INSTITUTION: UNIVERSITY OF ONTARIO INSTITUTE OF TECHNOLOGY

RFP NAME: ACE Base Building Extension

ADDENDUM NAME: Questions and Responses

ADDENDUM #: 1

DESIGN BY: BBA	DOC CONTROL DATE:
DRAWN BY: JJ	% COMPLETE:
CHECKED BY: DM	INITIAL:
DATE: 2018-09-17	
SCALE: AS NOTED	
FILE:	
DRAWING NO: SKA-01

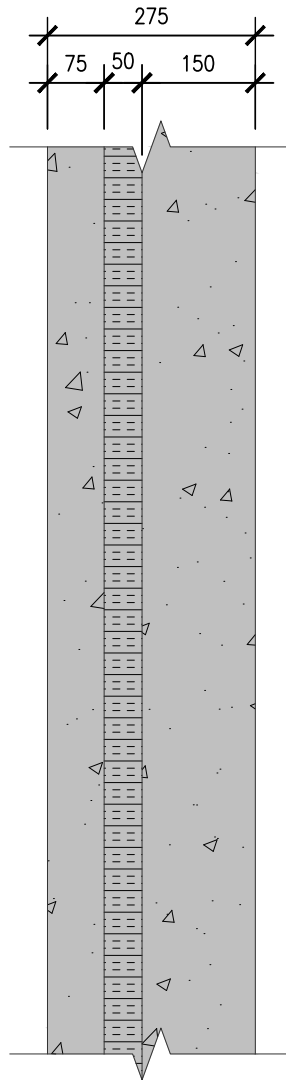
- 1.6 Refer to sketch SKA-02 dated September 20, 2018 for clarification of the precast wall composition.
- 1.7 Refer to the attached soil report prepared by V.A. Wood and Associates for Geotechnical information.

PRECAST PANEL COMPOSITION:

75mm EXTERIOR PRECAST CONCRETE PANEL
 50mm RIGID INSULATION
 125mm PRECAST CONCRETE BACKUP PANEL

FOUNDATION DETAIL

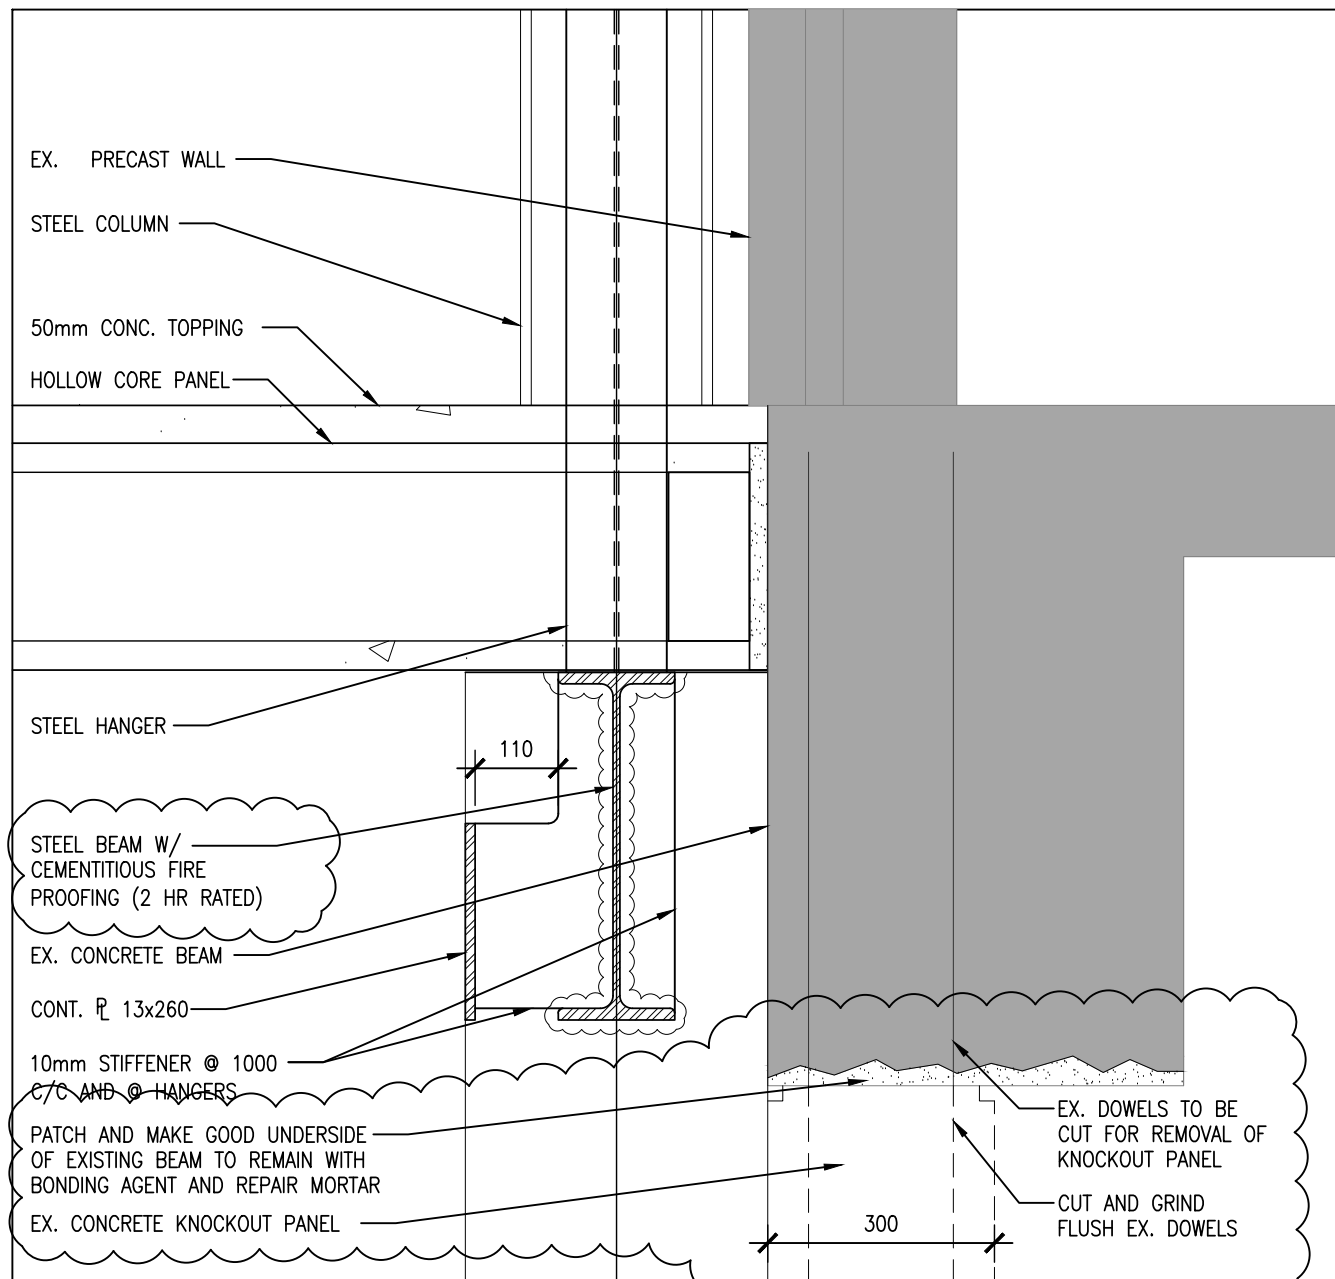
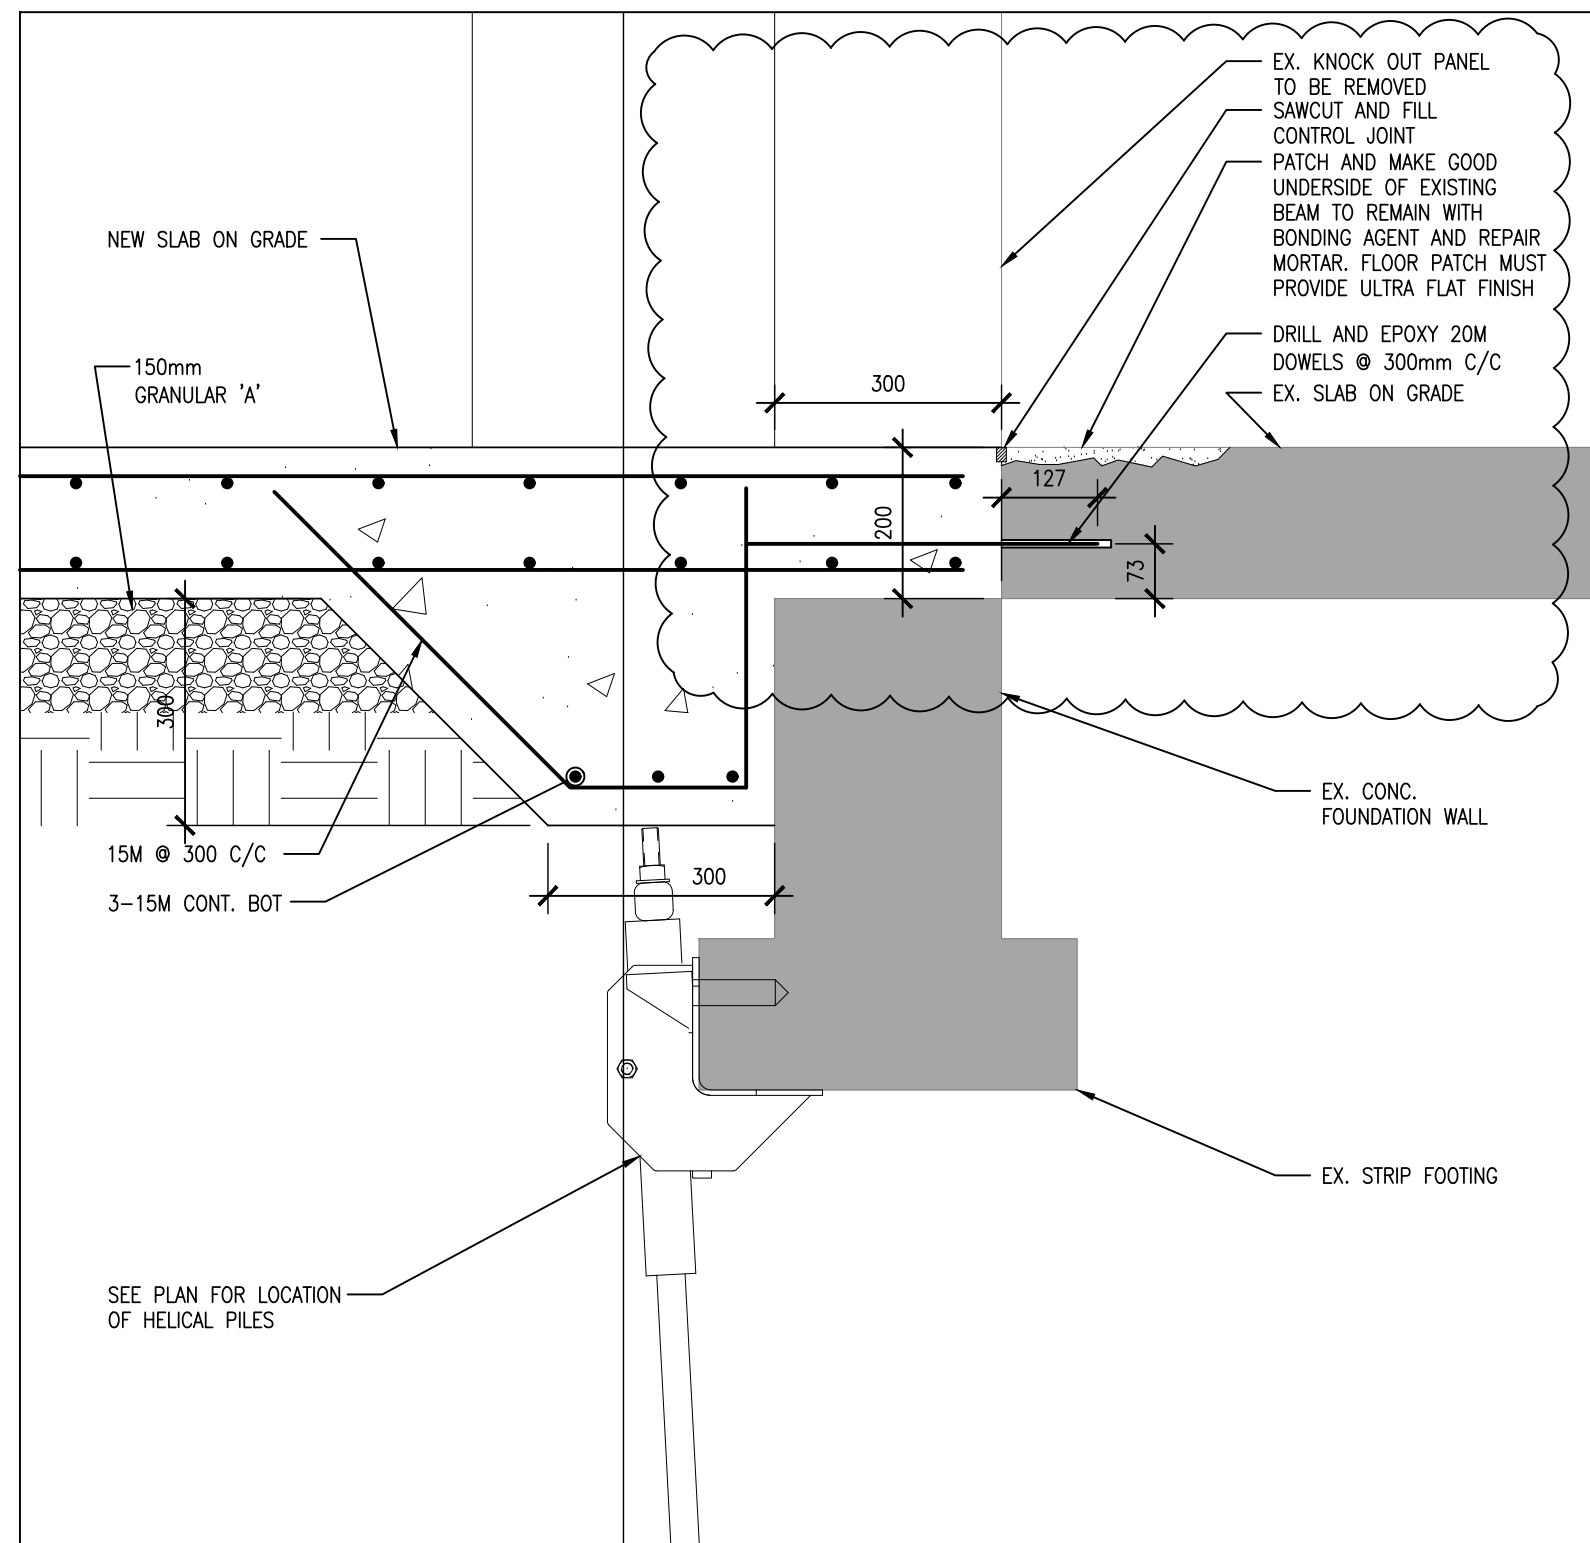
- 1.4 Refer to sketch SKS-03 dated September 17, 2018 for clarification of the fire resistance ratings and types on the structural steel.
- 1.5 Refer to sketch SKS-01, SKS-02 and SKS-04 for remedial repair work at the existing concrete beams, floor, and columns to remain around the knock out panel. Refer to the attached sketches to also clarify the reinforced concrete knock out panel wall thickness and height designated for removal.

(PARTIAL) FRAMING ELEVATION ALONG GL. R1

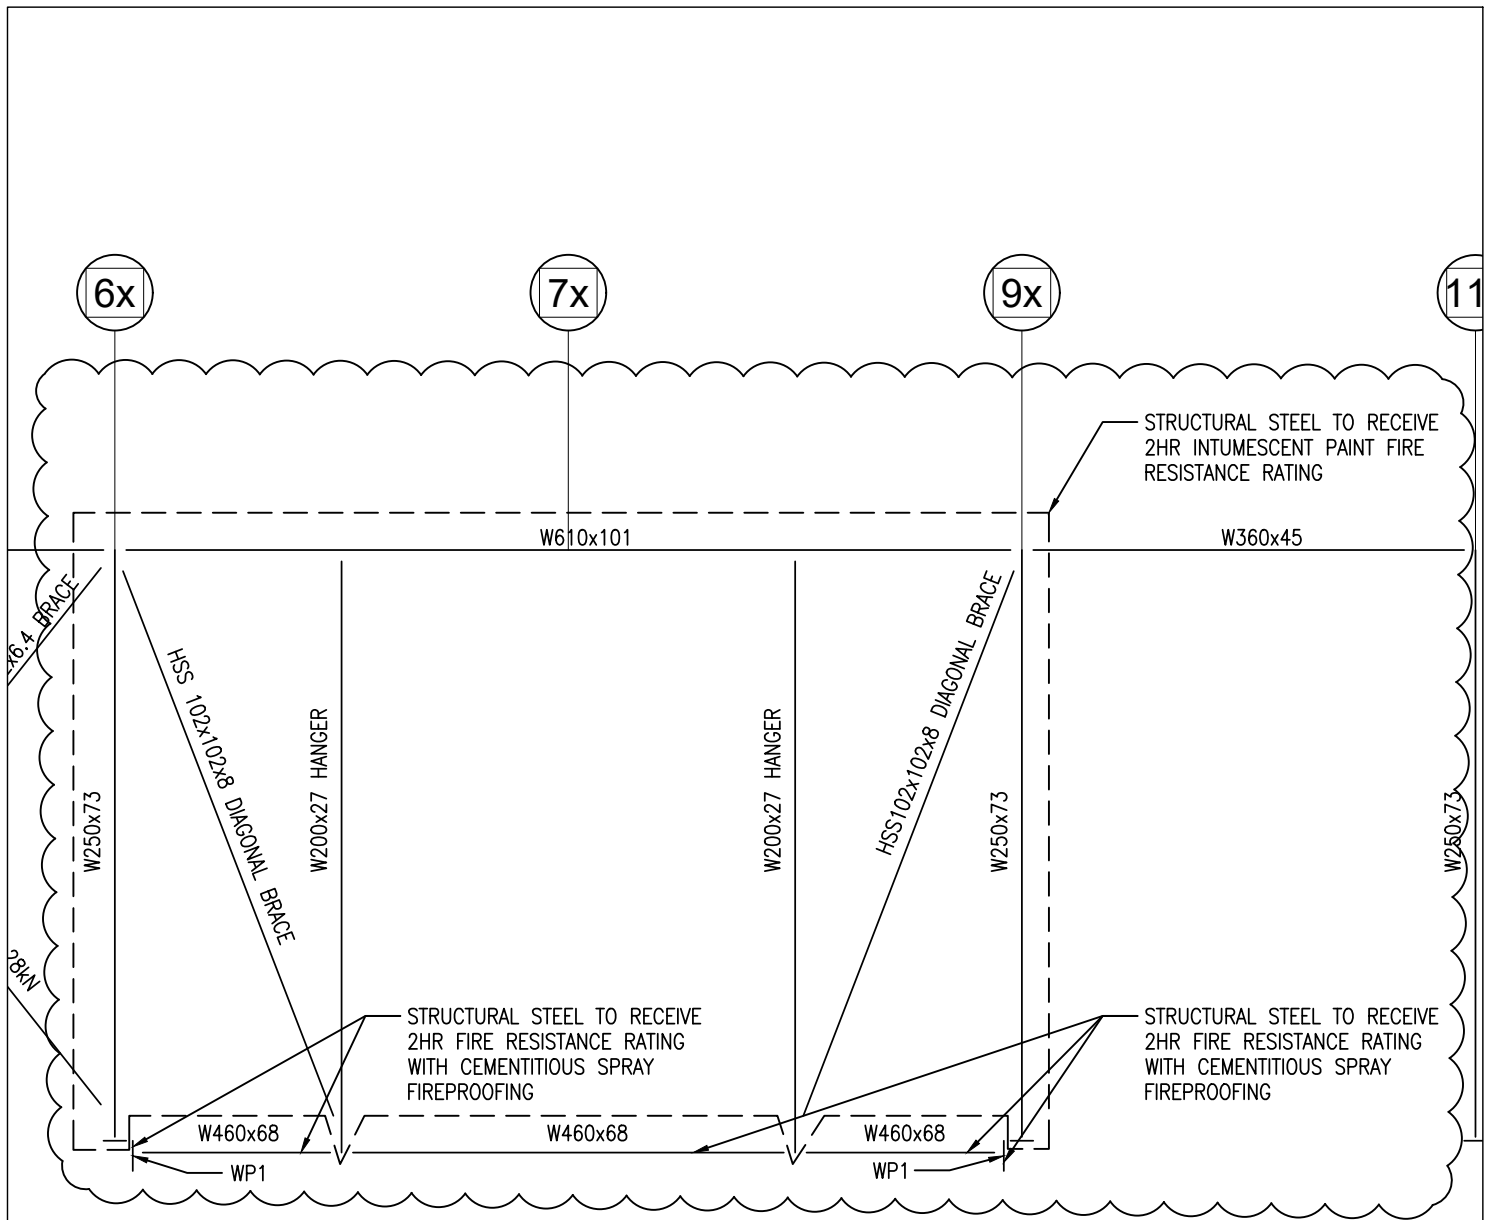
1.32 Question: Please clarify extent of Cementitious Fireproofing. It is indicated on Building Section 1/A401 and also implied on Structural Elevation 4/S301 with only a notation "to receive 2 hour Fire Resistance Rating" which I am assuming is the Fireproofing.

Answer: Refer to the sketches in the general addendum items for clarification of the fire resistance ratings for the structural steel.

**KNOCKOUT PANEL
REMOVAL PLAN DETAIL**

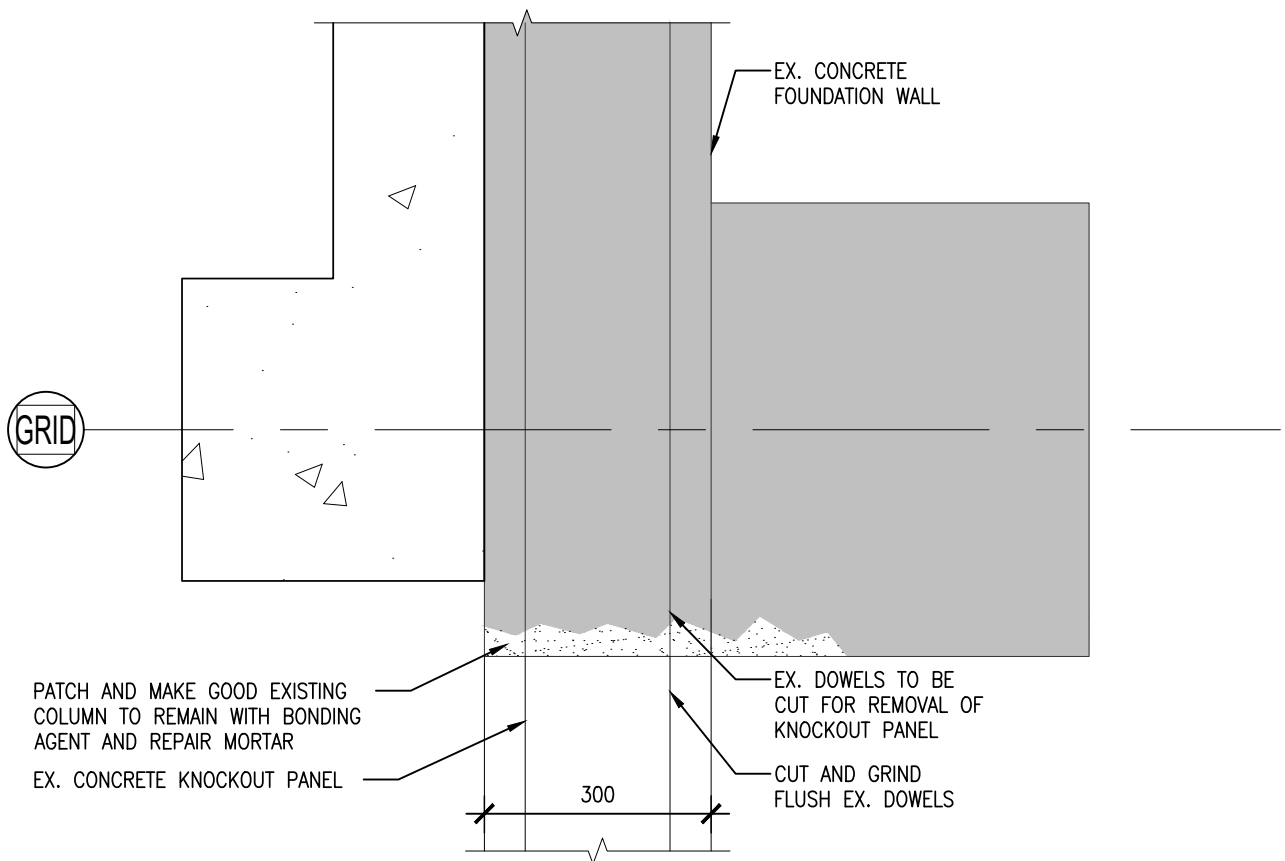
1.33 Question: Are there existing Building Details available showing reinforcing and thickness of both concrete walls and precast concrete panels to be sawcut and removed?

Answer: Refer to the sketches in the general addendum items for clarification of the concrete knock out panel and precast walls.

FAN COIL/MUA UNIT INSTALLATION DETAIL WITH THREE WAY CONTROL VALVES

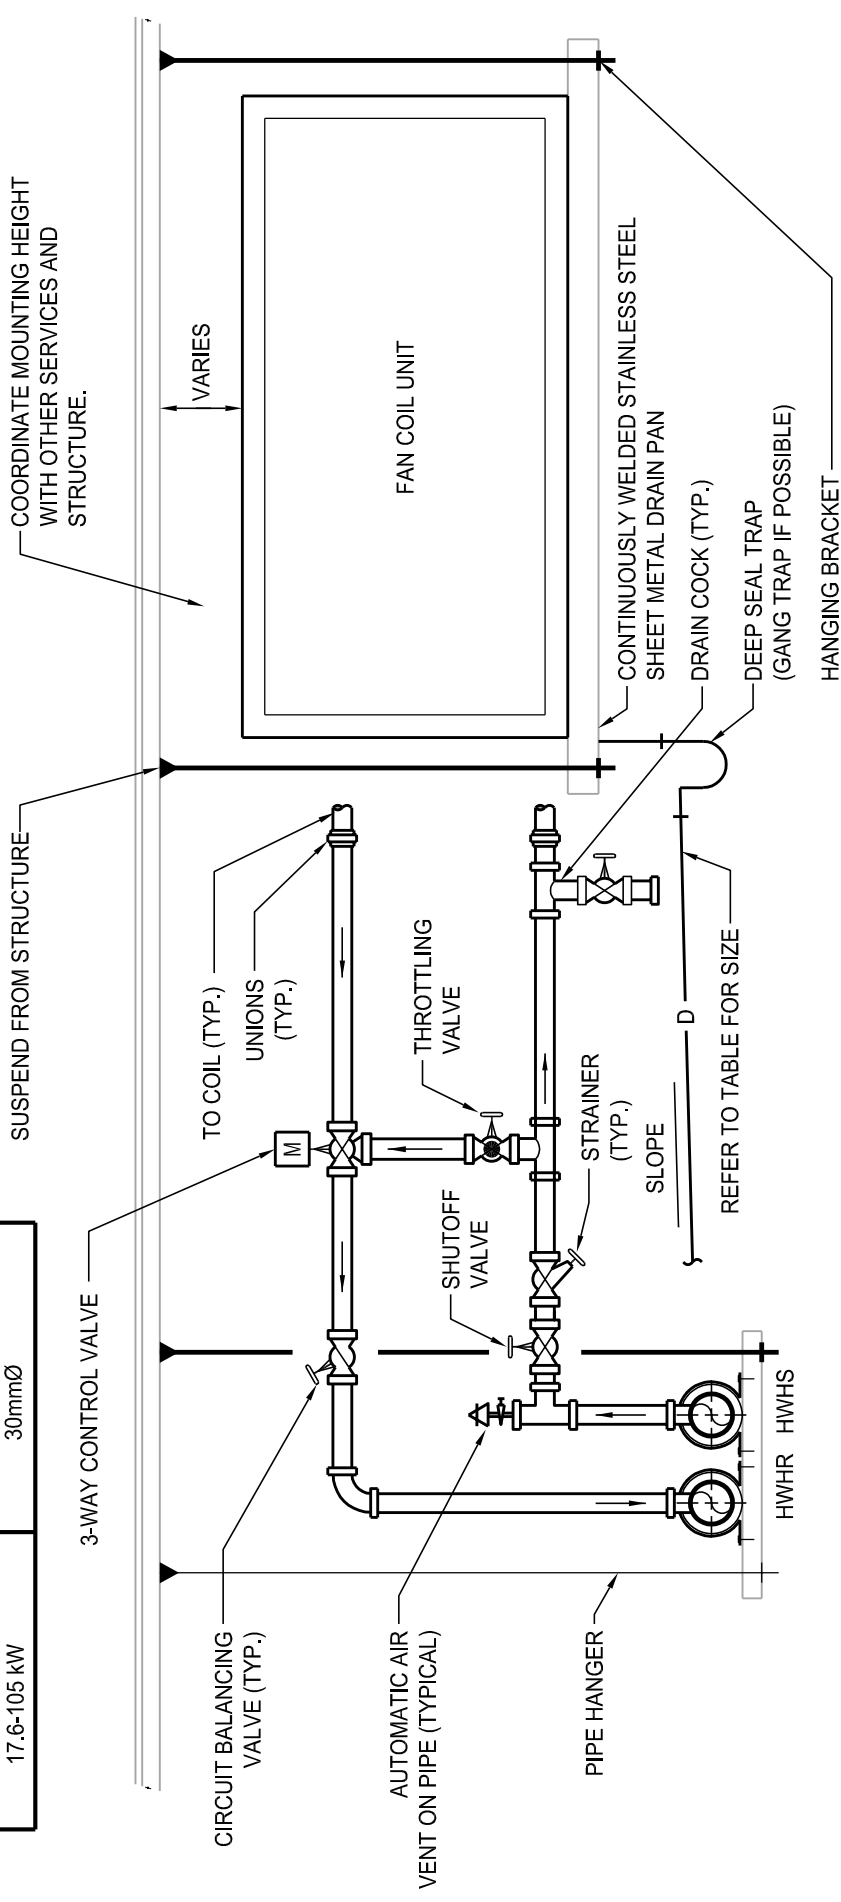
- .1 Add detail no.10 to clarify valving arrangement for fan coil and make up air unit coil connections. See attached detail.

FAN COIL COOLING CAPACITY	CONDENSATE DRAIN PIPE SIZE
0-7 kW	18mmØ
7.1-17.5kW	25mmØ
17.6-105 kW	30mmØ

NOTES:
 - TAKE BRANCH PIPES TO FAN COIL UNITS OFF TOP OF MAIN RUNS

DRAWING:
**ELECTRICAL SINGLE LINE
DIAGRAM**

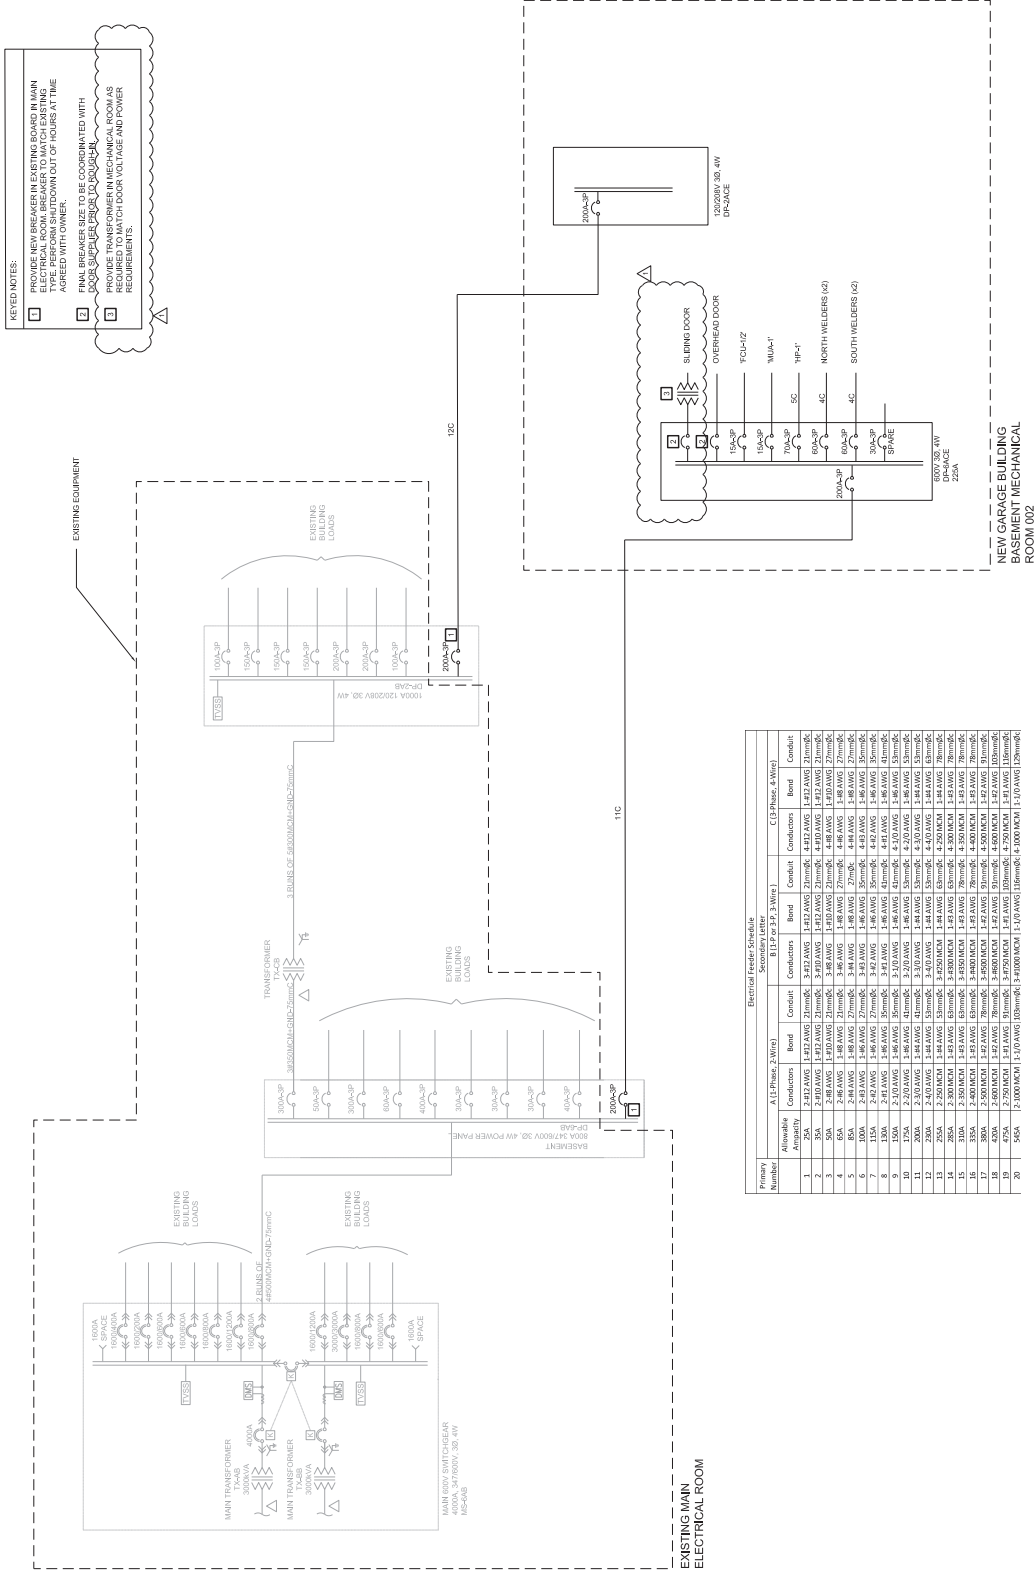
1.1. Drawing E003 – Electrical Singleline Diagram.
